Subject **Eskay Creek Revitalization Project – Notification of a Proposed Change to the Designated Project**

Eskay Creek Revitalization Project

KM46 Camp EAC Amendment Application

May 2026

Figure 2.1-2 presents the permitted facilities for the KM46 Advanced Exploration Camp.

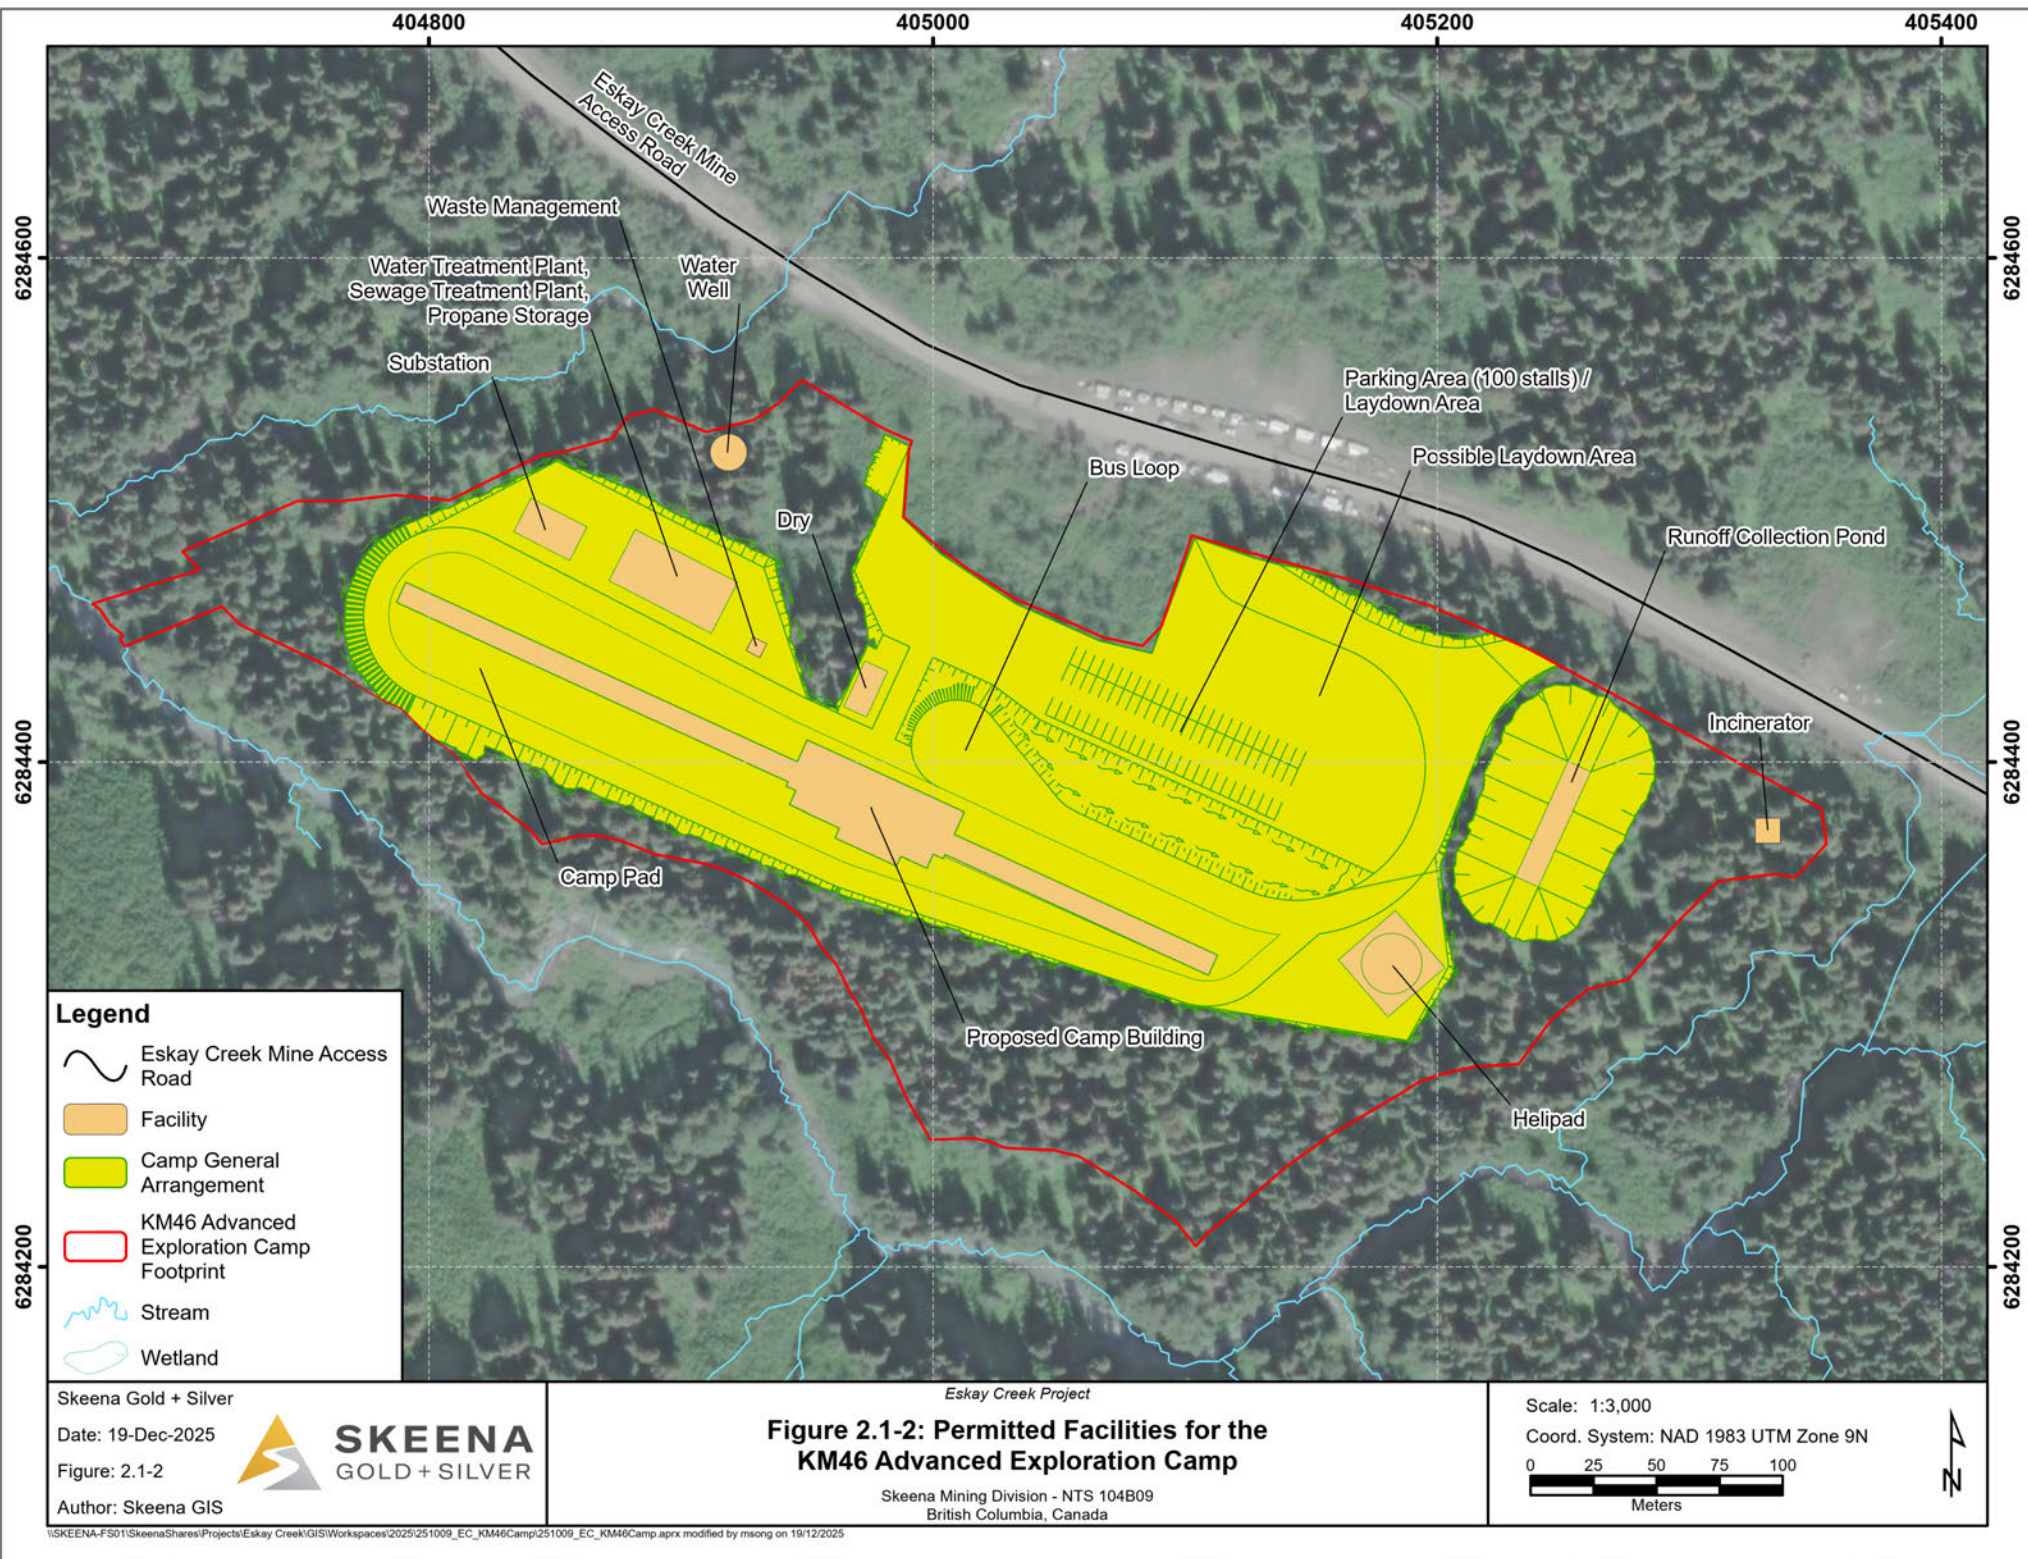
As part of the exploration phase of the Project, an Advanced Exploration Camp has been permitted and established at KM46 along the southern side of the Eskay Creek MAR (KM46 Advanced Exploration Camp; Figure 2.1-1). The KM46 Advanced Exploration Camp is accessed via the Eskay Creek MAR and includes a helipad and a security gate. Power to the KM46 Advanced Exploration Camp is provided by a modular substation. The permitted KM46 Advanced Exploration Camp area is 10.3 hectares (ha) and includes the following infrastructure and facilities:

- Dormitories (up to 381 beds),
- Kitchen/dining area,
- Boot room,
- Recreational/fitness facilities,
- Medical facilities,
- Parking area,
- Dry building,
- Propane storage,
- Water treatment plant,
- KM46 groundwater well (potable water source),
- Sewage treatment plant,

Figure 2.2-1: Proposed Mine Camp Area

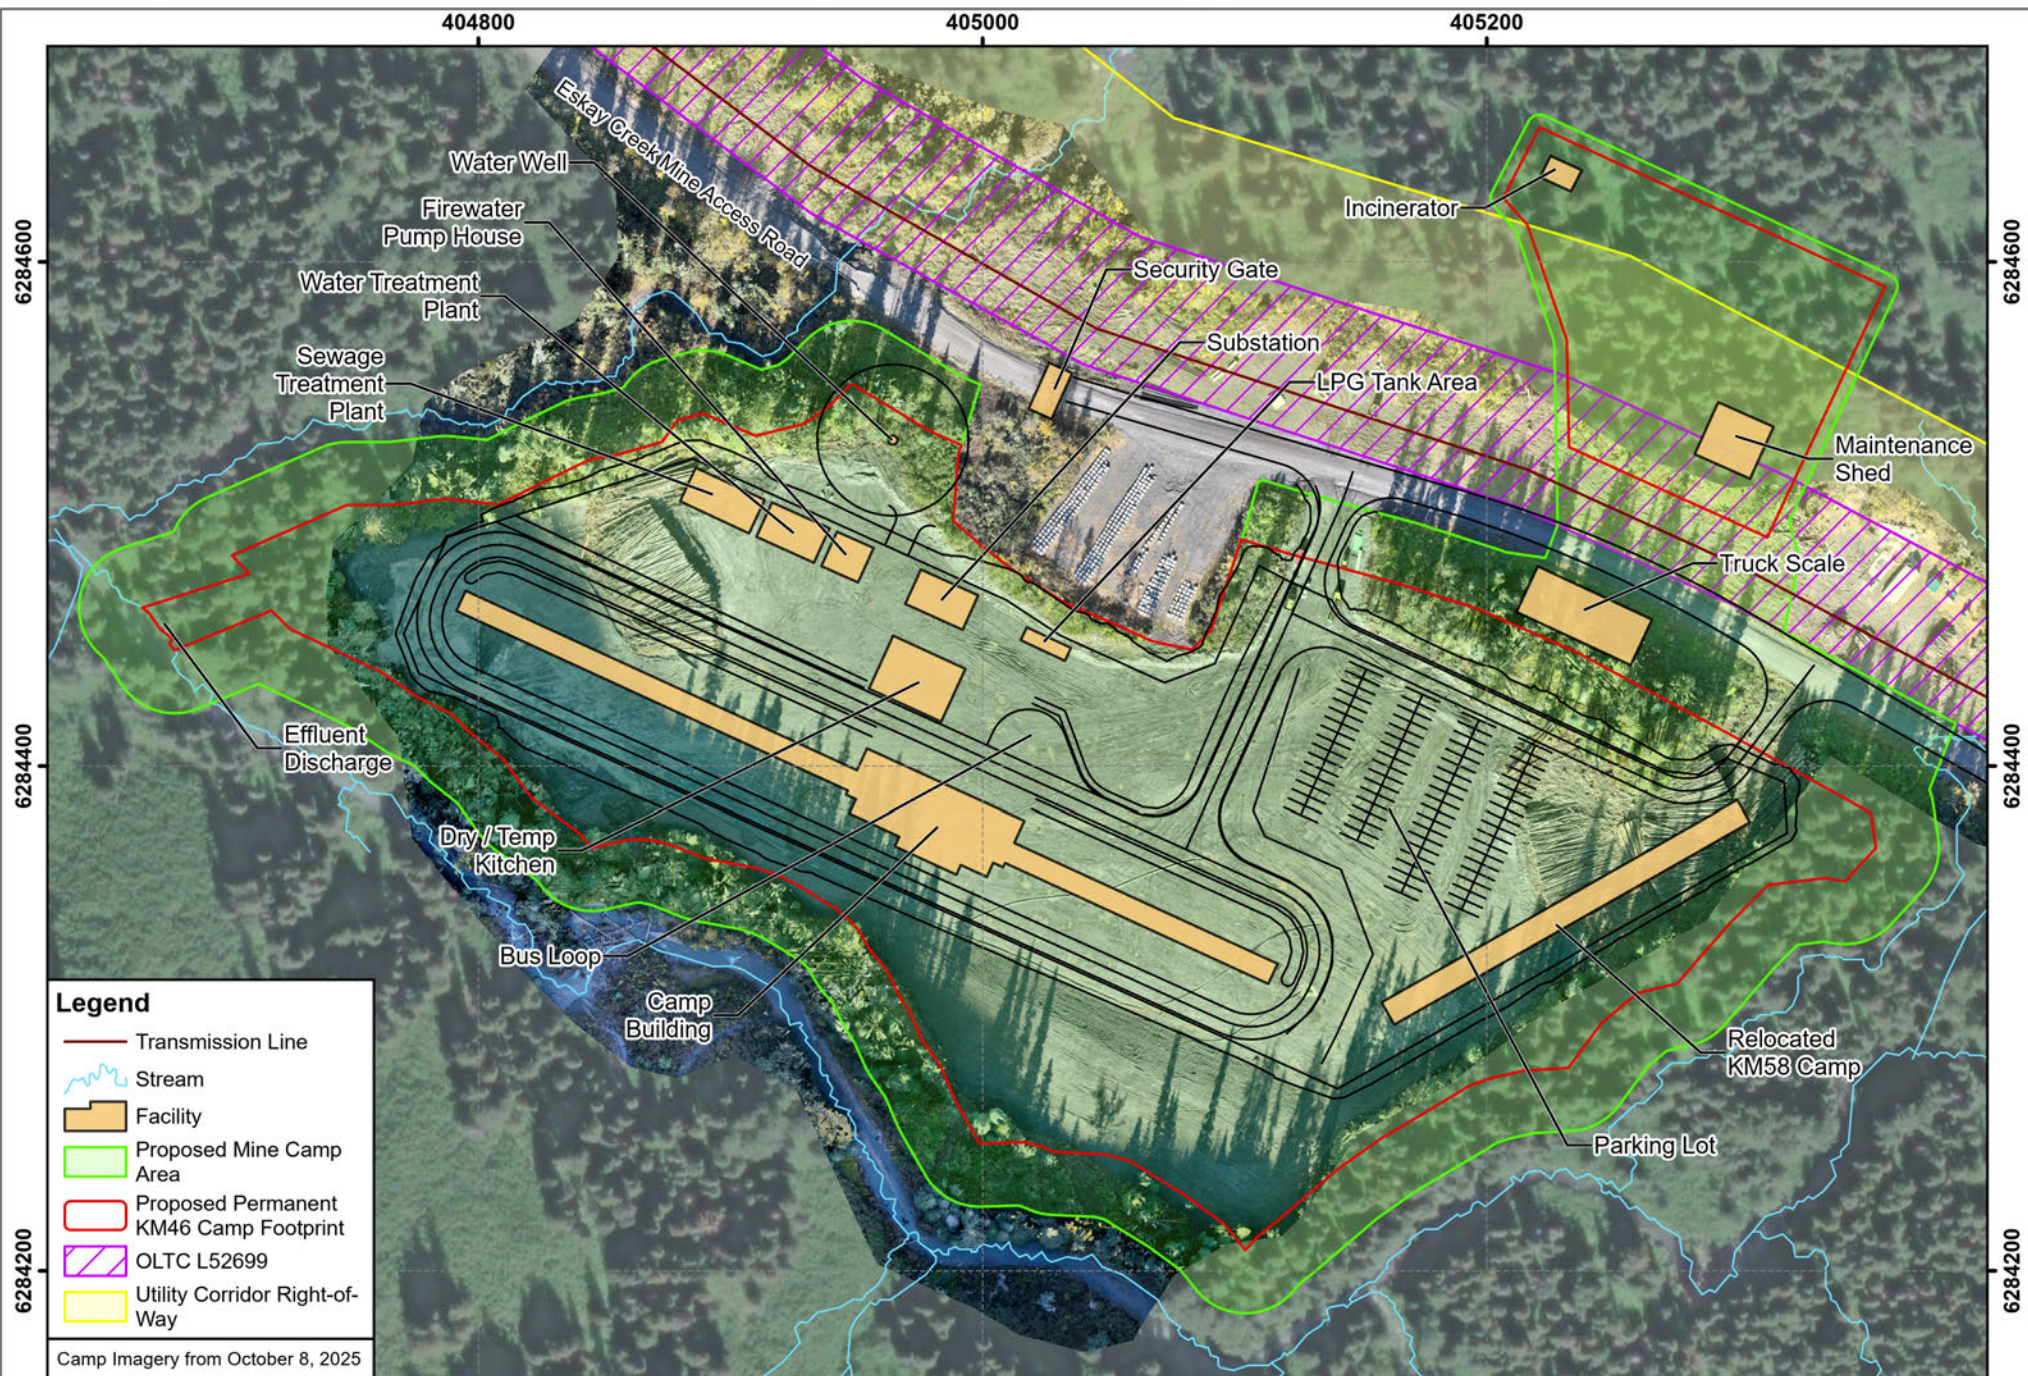
To allow for design flexibility, Skeena Resources is seeking an EAC Amendment to include the proposed Mine Camp Area presented on Figure 2.2-1. This area includes a 25 m buffer around the existing permitted KM46 Advanced Exploration Camp and a 5 m buffer around the planned waste and maintenance area. The proposed Mine Camp Area would encompass a total of 16.5 ha. There is a 40m Riparian Management Area setback between the Camp Licence of Occupation (LoO) boundary and Volcano Creek and 30m Riparian Management Area setback between the Camp LoO boundary and the tributaries to the east and west. With the exception of the wastewater effluent infrastructure, there currently is no planned disturbance within the Riparian Management Areas. To be conservative, the buffer zone associated with the proposed Mine Camp Area is considered as additional land that could be cleared in this assessment, after deduction of the area overlapping with the Transmission Line Crown Tenure (0.39 ha), which is already permitted to be cleared.

Figure 2.2-1 presents the planned layout for the proposed Permanent KM46 Camp.

1. Increase in housing capacity (+ 119 beds).
2. Land clearing (+ 4.97 ha).
3. Incinerator relocation.

The Mine Camp Area shown on Figure [number to be determined by the EAO] includes a Permanent Camp with possible expansion up to 500 bed units and mine dry, and associated ancillary infrastructure.
